S2S Cycle & Footway Interim Works Bull Road to Causeway Road

Stage 3 Road Safety Audit

August 2017

2.2.5 Problem (S5) Carriageway Surface at Crossing on Bull Road

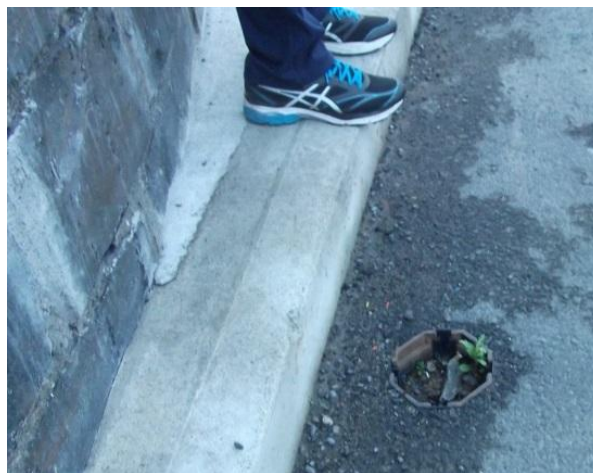
The existing carriageway surface at the crossing presents a trip hazard and an uneven surface for both pedestrians and cyclists. Additionally grit/loose gravel on the carriageway may result in vehicles skidding leading to loss of control incidents.

It is recommended the carriageway is finished to an appropriate standard to ensure an even surface for pedestrians/cyclists/vehicles.

2.2.12 Problem (S12) Accesses to Commercial Premises on western side of Clontarf Rd

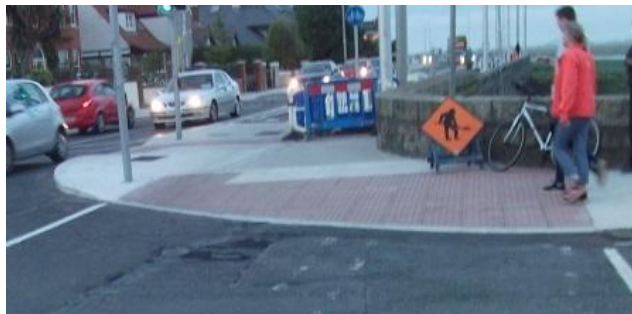
Vehicles must cross the footway on the western side of Clontarf Rd (to the north of the Clontarf Rd/Bull Rd junction) to gain access to the adjacent commercial premises. The footway surface across these accesses is almost flush with the adjacent road carriageway. Due to the lack of height difference (less than 25mm) there is a risk that visually impaired pedestrians may fail to observe the edge of the footway and inadvertently enter into the adjacent road carriageway, leaving them at risk of conflict with vehicles travelling northbound along Clontarf Road.

As soon as the opportunity arises, it is recommended that either a kerb upstand of greater than 25 mm is provided or tactile paving is provided to warn pedestrians of the adjacent road carriageway.

2.2.20 Problem (S20) Bus Stop South of Dollymount Park

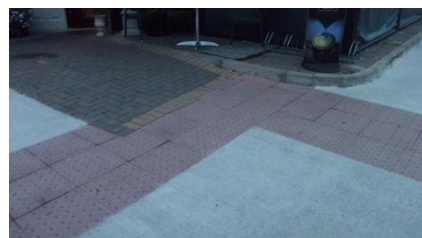
The auditors are concerned that when northbound buses are stopped at the bus stop (as located to the south of Dollymount Park), forward sight visibility to the new pedestrian crossing (and associated signal heads) may be restricted for northbound vehicle drivers. Failure to provide adequate forward sight visibility to the pedestrian crossing may result in vehicle drivers failing to observe a pedestrian utilising the crossing, and/or vehicle drivers may not be given insufficient time to reduce their speed, both of which increases the potential for conflict between a vehicle and a pedestrian.

2.2.29 Problem (S29) Low Wall Height – Throughout Scheme

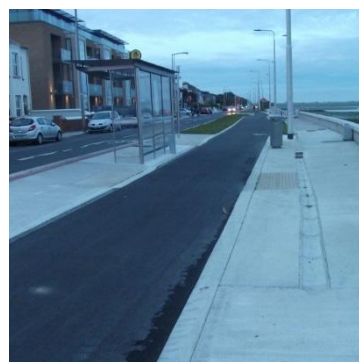
The auditors are concerned about the low sea wall height throughout the scheme and the flat top capping provided, particularly opposite the Mount Prospect Avenue junction (pictured). This presents a hazard to visually both impaired pedestrians (trip hazard) and to children who may be encouraged to run/walk/climb on the wall leading to falls from a height into the sea and/or drowning.

This problem was also noted during the Stage 2 RSA undertaken by PMCE (Problem Ref. 3.1.5).

We note the designers' response to the PMCE Stage 2 RSA problem, nonetheless the problem still remains. At a very minimum the designers recommend the provision of angled along the top of the wall to ensure children cannot walk/run along the top of the wall. This angled capping would still allow pedestrians to rest at the wall without sitting on top of it completely.

3.1.1 Comment (C1)

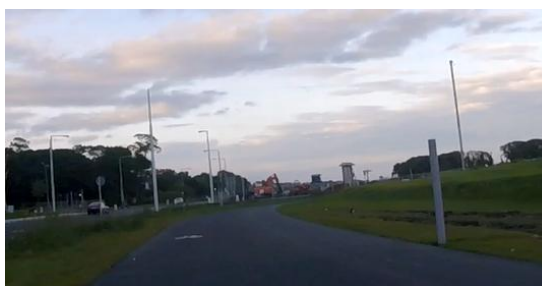
Prior to undertaking the audit, the audit team were informed that residents had raised concerns in relation to vehicles parked within the cycle track. The audit team did not witness any inappropriate parking during the site audit. Nonetheless it is recommended the situation is monitored and if the problem persists/arises an adequate parking enforcement regime should be implemented or the provision of physical barriers to restrict vehicle access should be provided.
